United States Department of the Interior
OFFICE OF SURFACE MINING
Reclamation and Enforcement
BROOKS TOWERS
1020 15TH STREET
DENVER, COLORADO 80202

PLAN OF ACTION FOR EVALUATION OF
UNDERGROUND RESERVOIR

RE: Revision to the Mining and Reclamation Plan, U.S. Fuel
Company, Hiawatha Complex, ACT/007/011, Folder No. 2,
Carbon County, Utah

Determination of Adequacy
Proposed Unit Train Loadout
Response to June 1, 1984 Submittal

Figure 9
HIAWATHA MINES COMPLEX
EXISTING SEDIMENTATION PONDS

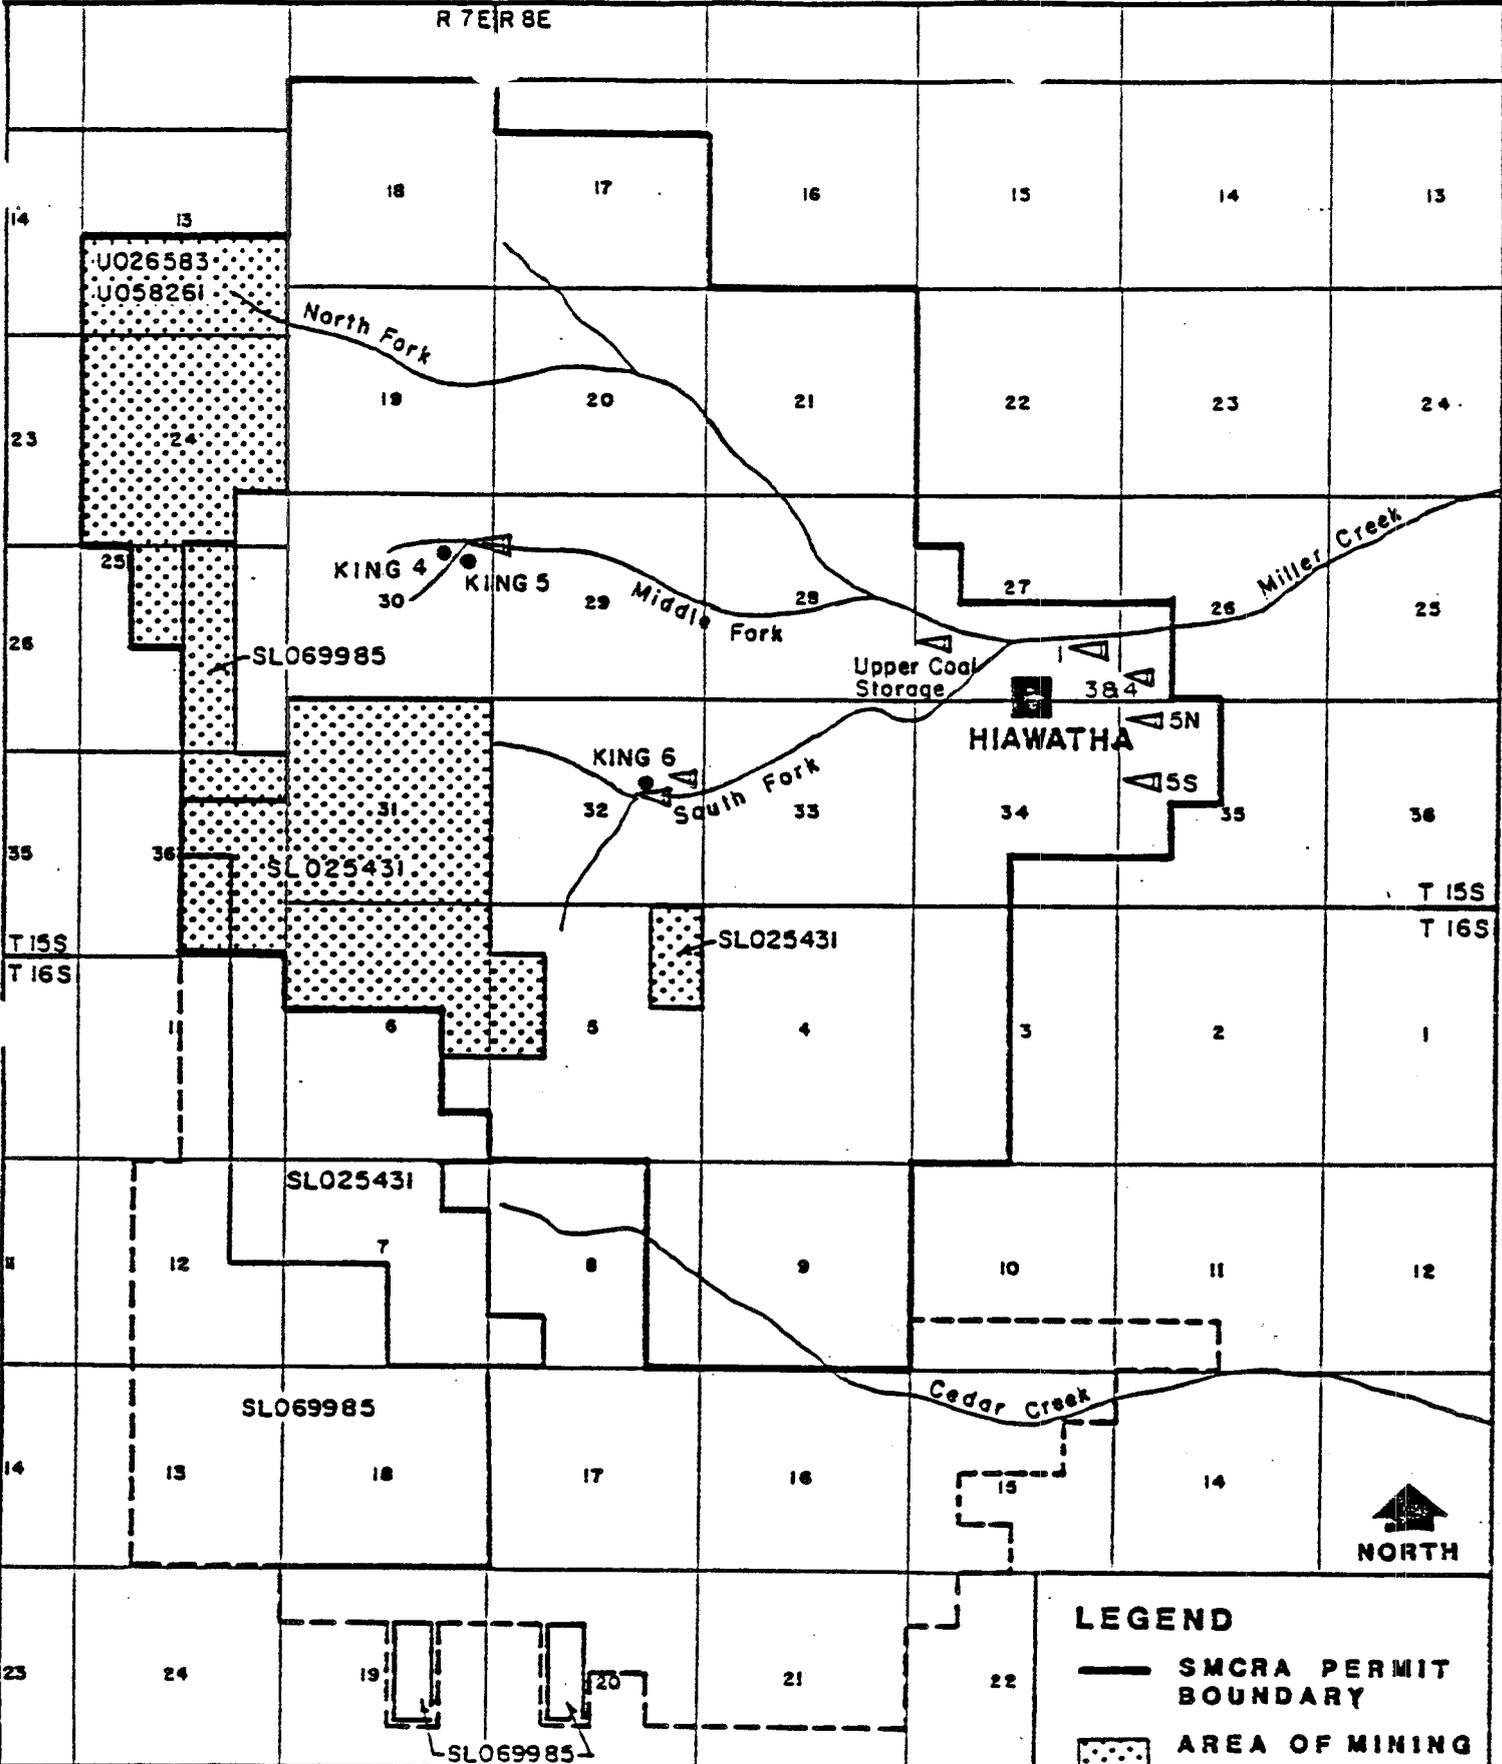
The applicant has constructed a small (about 1 acre) ventilation pad on the Right Fork of the North Fork of Miller Creek (see Figure 9). Because of the small area of disturbance, a small area exemption was allowed (UMC 817.42 (a)(3)), and the applicant is using strawbales to control sediment from the area. This is in compliance with UMC 817.42 and 817.45.
